STATUTORY RULES OF NORTHERN IRELAND

**Traffic Signs (Amendment No. 4)
Regulations (Northern Ireland) 1996**

2. Part III (markings on the road) of Schedule 1 to the Traffic Signs Regulations (Northern Ireland) 1979(2) shall be amended as follows—

1060

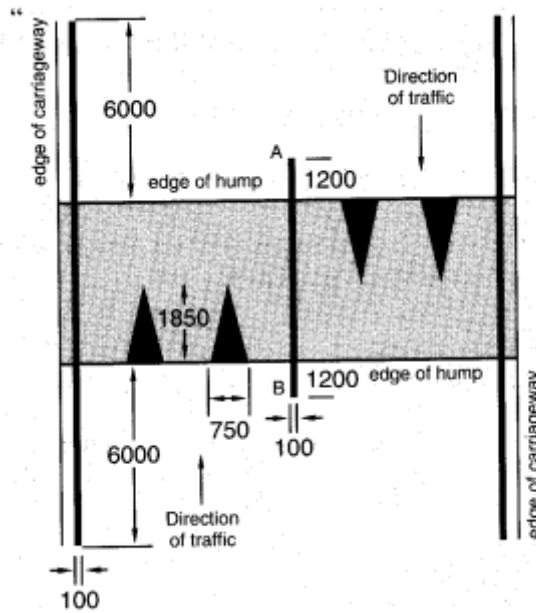
- (a) for diagrams 1060, 1060.1, 1061 and 1061.1 and the words under them substitute the following diagrams and words specified in or under them—

“To indicate to vehicular traffic the presence of a round top road hump extending across the whole width of the carriageway.

Permitted variants:

- (a) The longitudinal line adjacent to the edge of the carriageway may be omitted when the longitudinal line in diagram 1016.1, 1017 or 1018 is placed in the position of that line.

- (b) Where more than one traffic lane is available to traffic proceeding in the same direction, the longitudinal white line marked AB shall be placed between each traffic lane and the two triangular white markings placed on each traffic lane.

- (c) Where traffic is permitted to proceed in one direction only across a hump, the triangular white markings shall be placed only on the side of the road hump facing approaching traffic.

- (d) Where traffic is permitted to proceed in two directions in a single traffic lane across a hump, the two triangular white markings shall be placed on both sides of the hump.

- (e) Where the carriageway width is less than 6,000 millimetres the longitudinal line marked AB shall be omitted.
